LAND AT ELMSBROOK, BICESTER: **PROPOSED RESIDENTIAL DEVELOPMENT**

Evidence of Eur Ing D M Mason MBA BSc(Hons) CEng MICE DipEM

Planning Inspectorate Ref.No. APP/C3105/W/23/3315849

Cherwell District Council Application No. 21/01630/OUT

Proposed Construction Access E drawing 46600-1100-T-011 rev F by VTP.

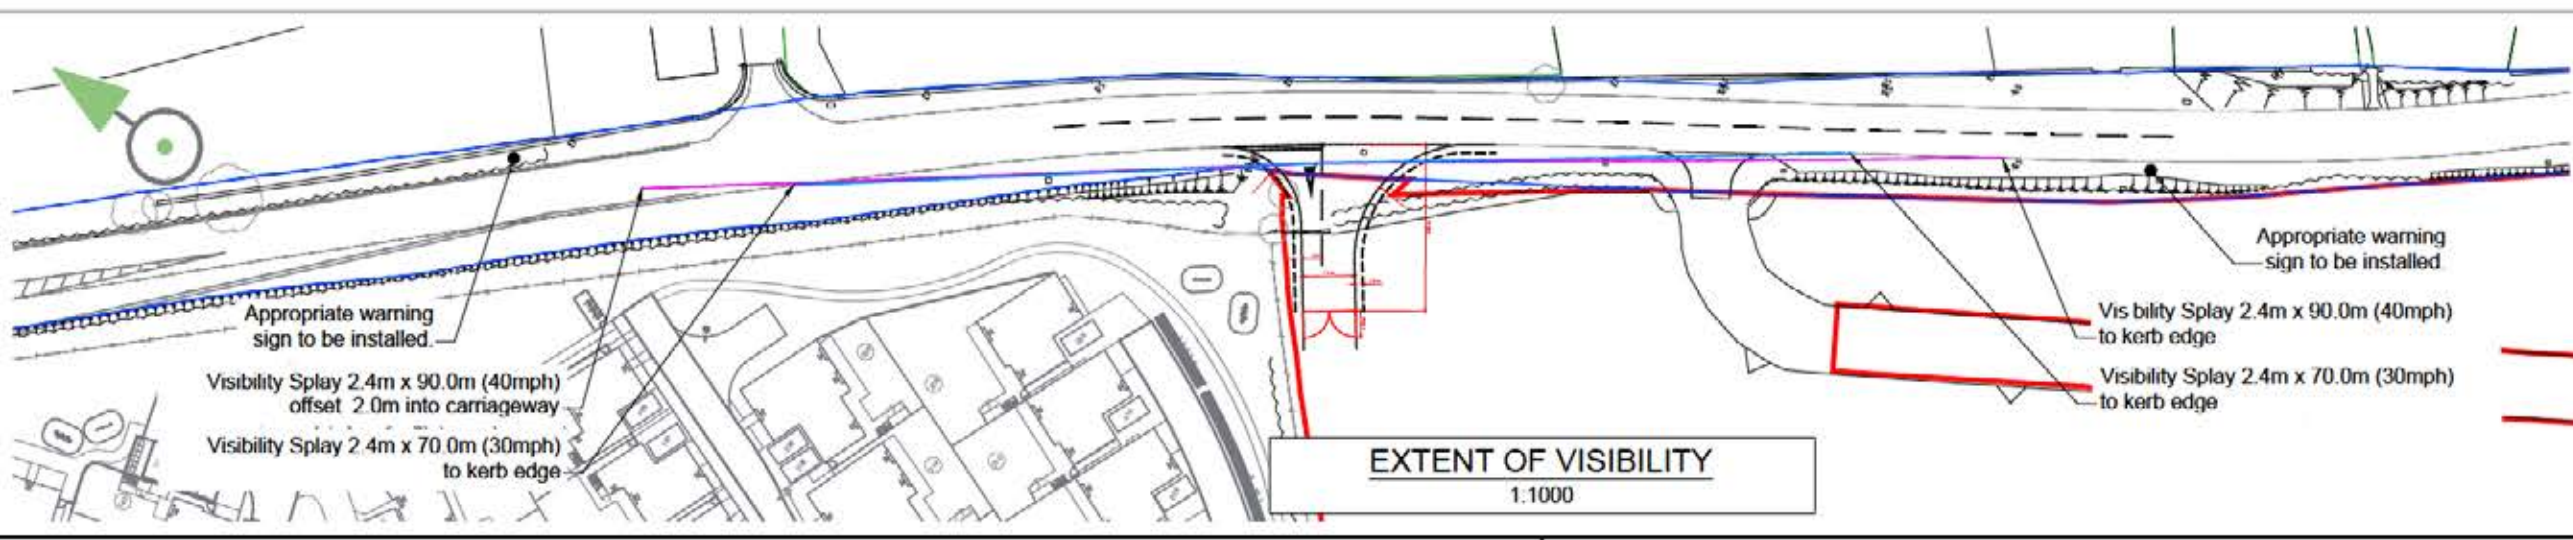
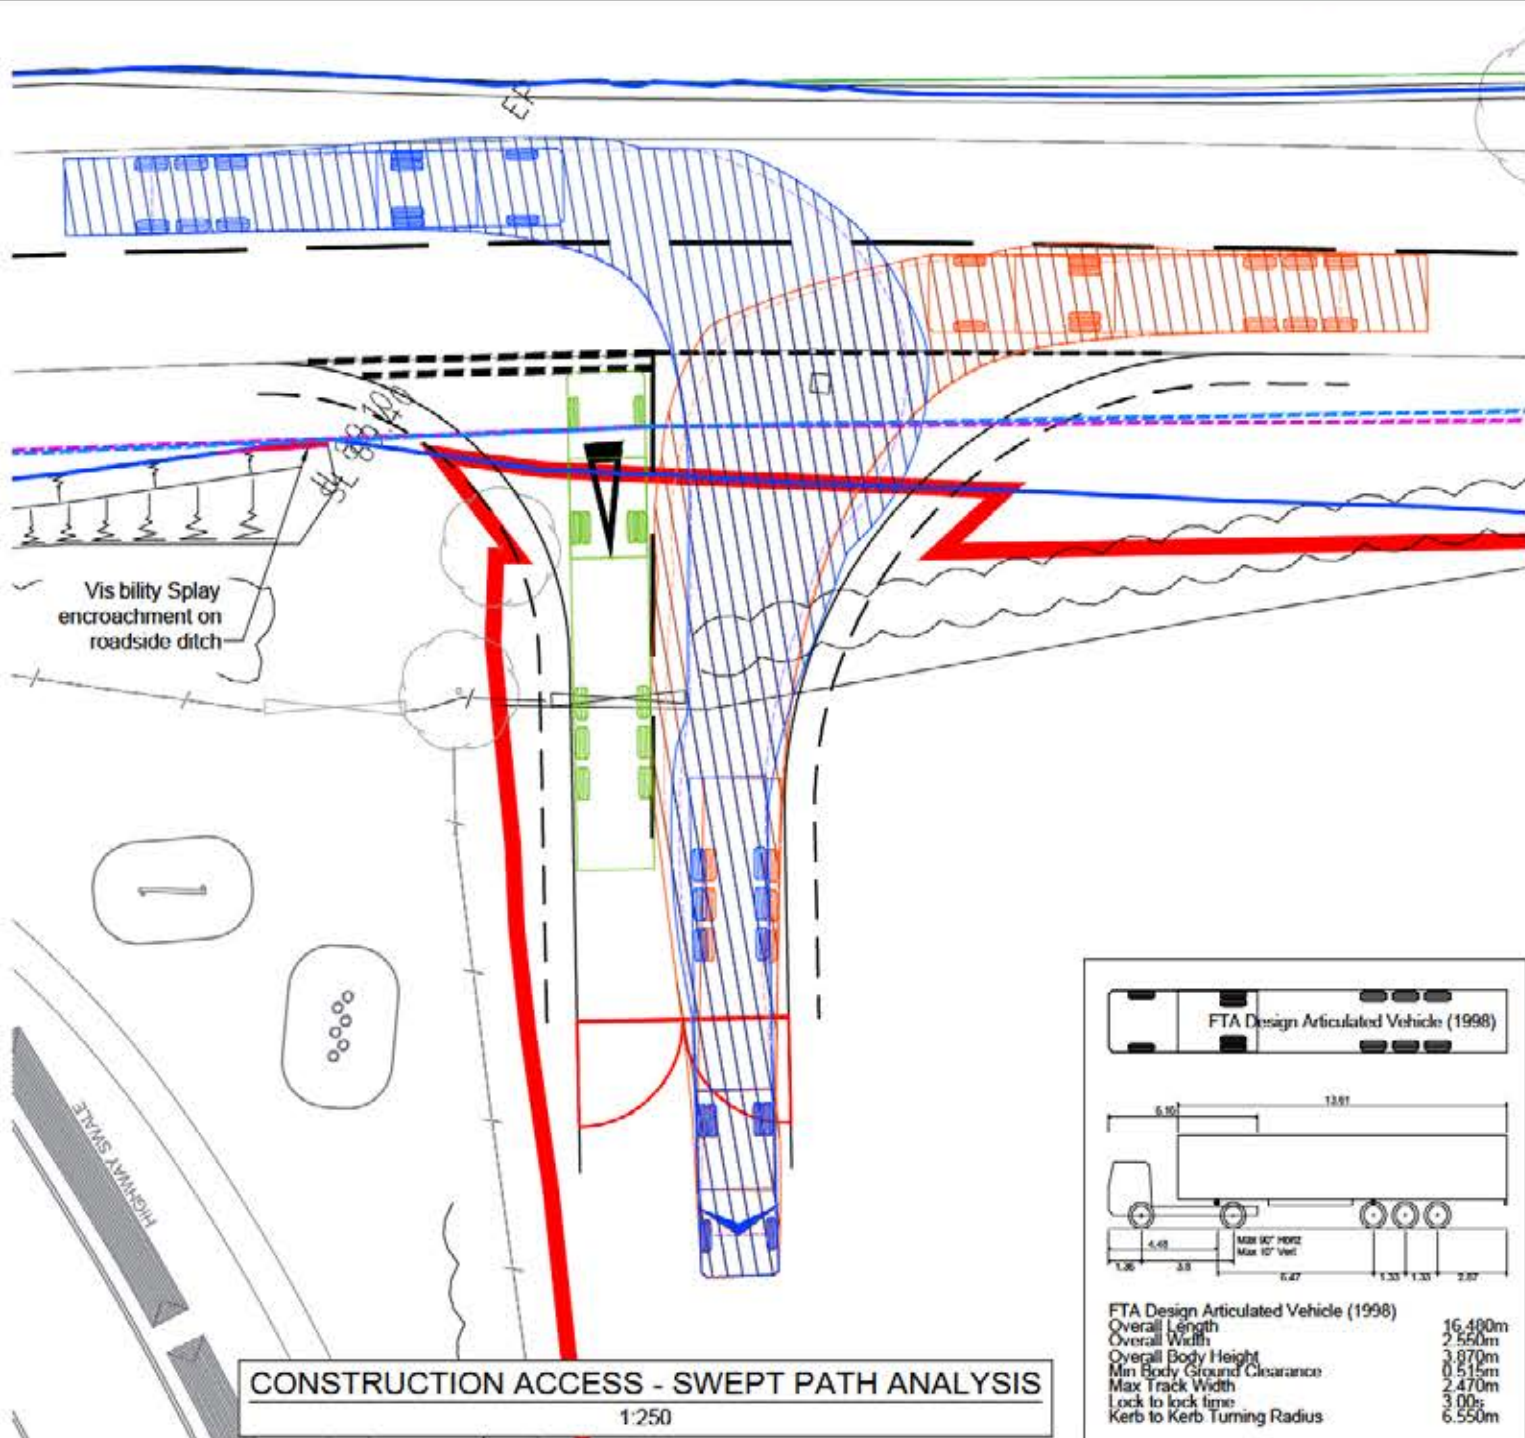
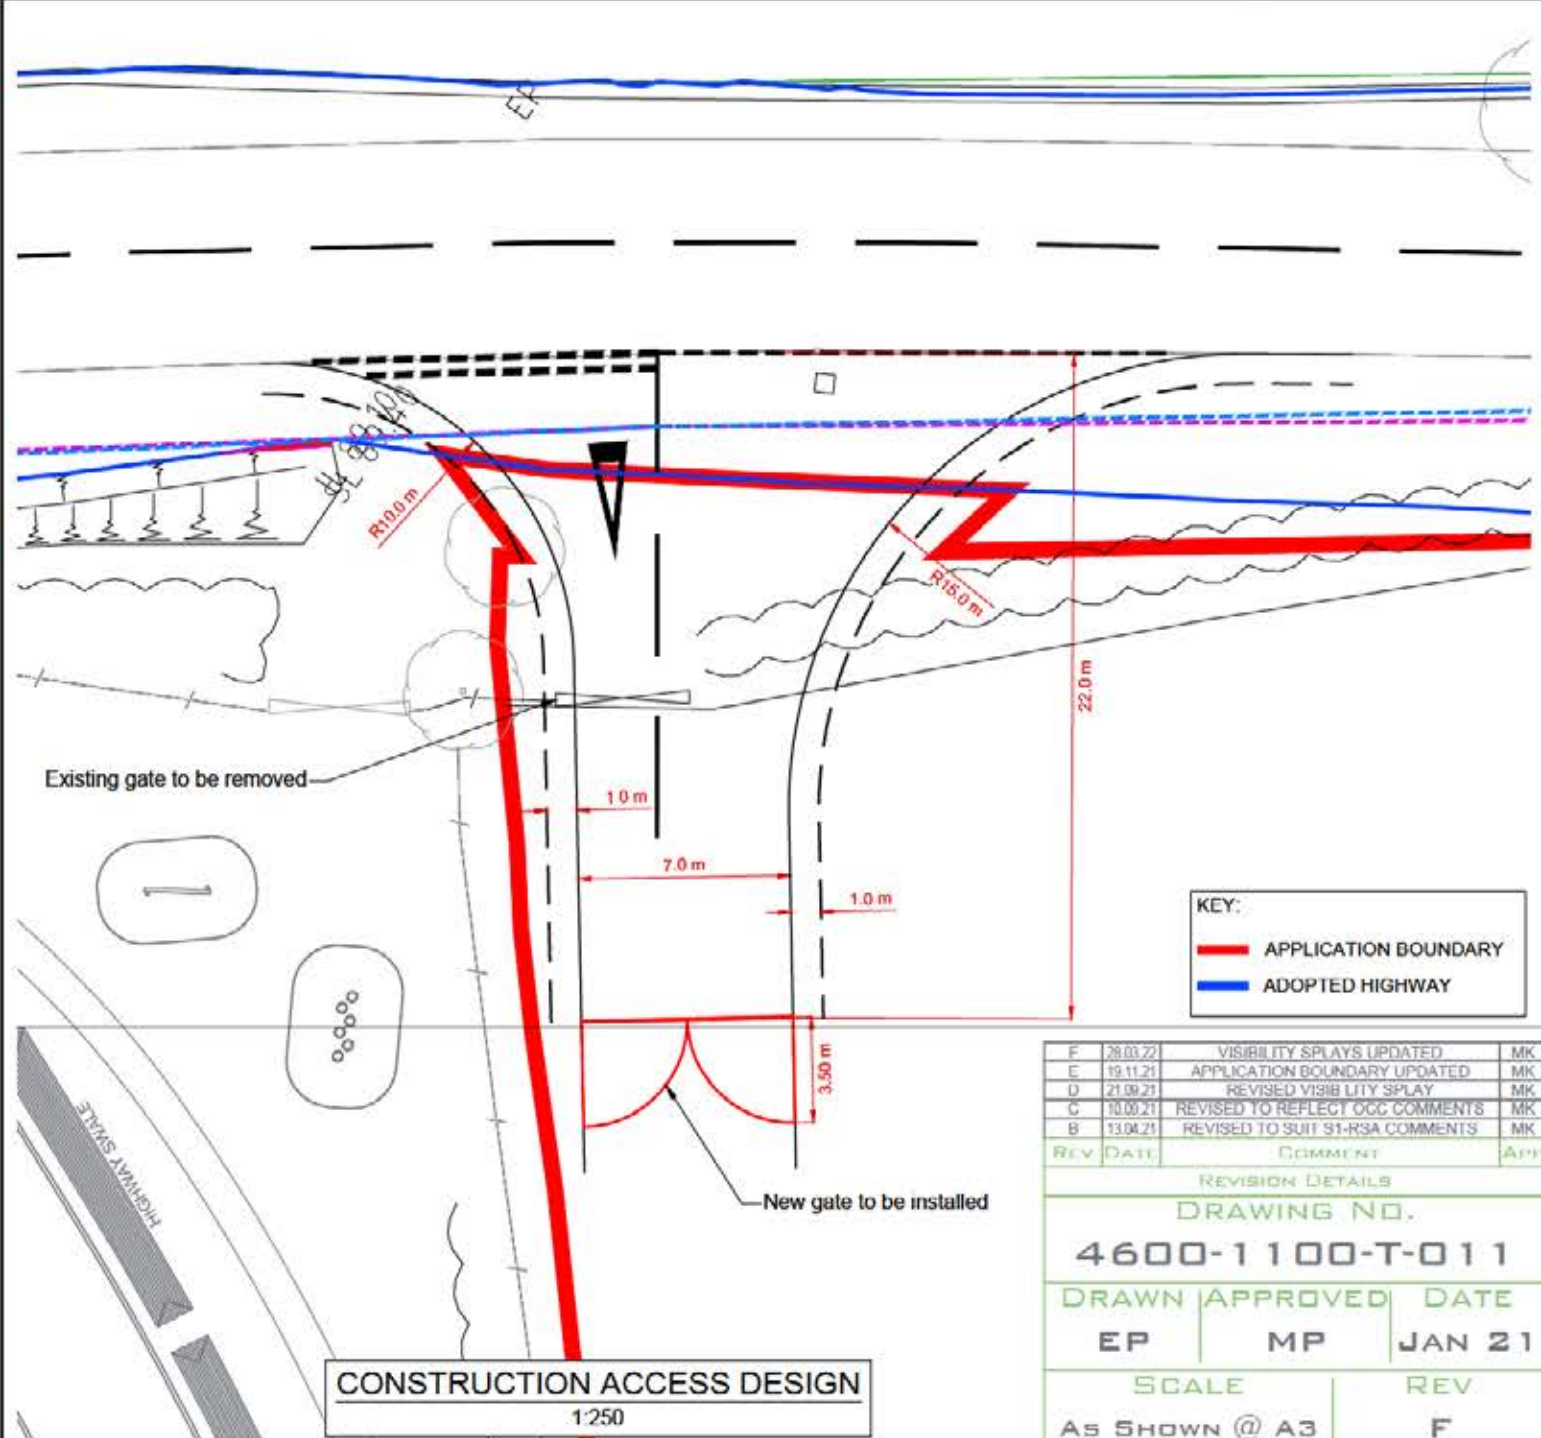
9.9 I have considered the proposed construction access E drawing 46600-1100-T-011 rev F by VTP reproduced in Appendix 5. I note that the visibility 'Y' distance shown for the visibility splays looking right (looking to the east) is 90 metres. The drawing notes that the speed limit adjacent to the proposed access is 40 miles per hour. Highway England (HE) standard CD109 states at Table 2.5 that the design speed for a 40 mile per hour urban road is 70 kilometres per hour. It then states in Table 2.10 that the desirable minimum stopping sight distance for that design speed is 120 metres. HE standard CD123 then states at Figure 3.4 that the visibility 'Y' distance at a priority junction should be the desirable minimum stopping sight distance.

9.15 It may be possible to amend Access E to provide a junction meeting standards. Acquisition of land adjacent to the proposed Access E may allow the provision of visibility splays meeting standards, that it splays with a 'Y' distance of 120 metres and splays to the nearside carriageway edge. It is for the Appellant to study this possibility.

Drawing OP4/a by Roger N Cross Services,
Access to Home Farm, Planning Permission 01/01836/LB.

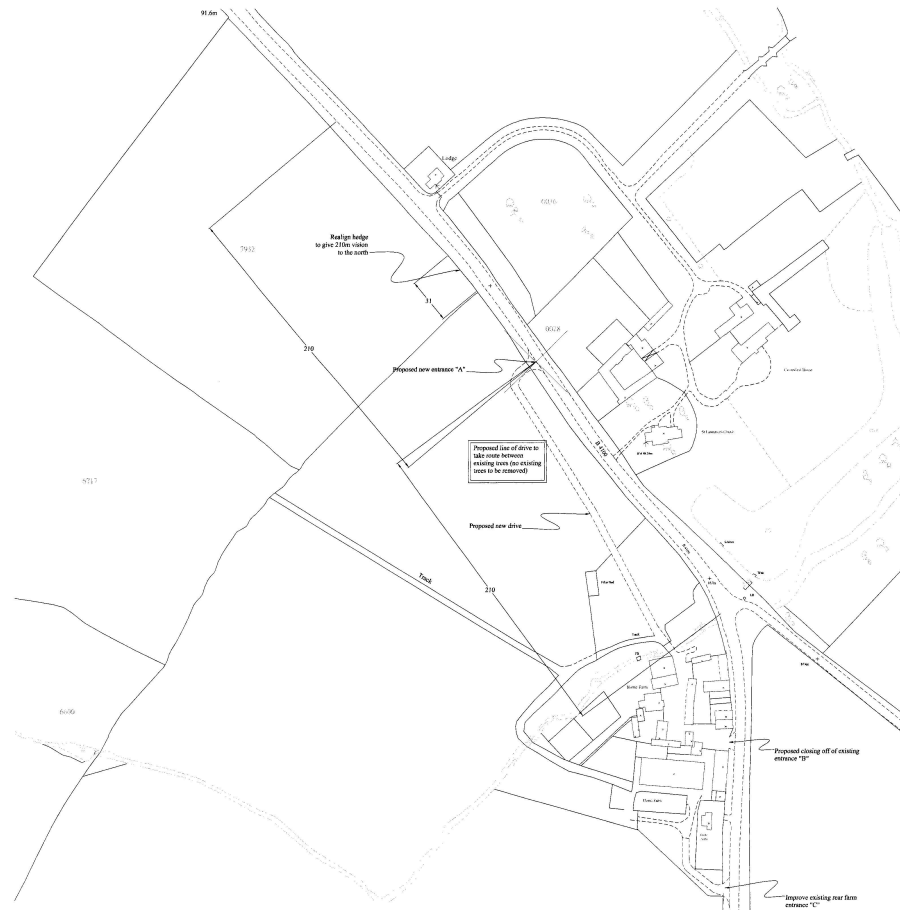
9.17 Drawing OP4/a by Roger N Cross Services reproduced in Appendix 6 shows the existing access into the Home Farm site. This access was granted under planning permission 01/01836/LB.

- 9.18 This Home Farm access provides visibility splays with a 'Y' distance of 210 metres. This is substantially more than the 120 metres required for the speed limit of 40 miles per hour on the B4100 Banbury Road. The access shown on the drawing has adequate visibility splays.

- 10.18 The existing Home Farm access provides adequate visibility splays with a 'Y' distance of 210 metres. This access is within the red line of the Appeal application. It is suitable to form a permanent access to the eastern parcel of the Appeal site. It is for the Appellant to pursue this possible permanent access alternative. Until there is adequate resolution of the problems at proposed Access E, planning consent should not be granted for the Appeal development.
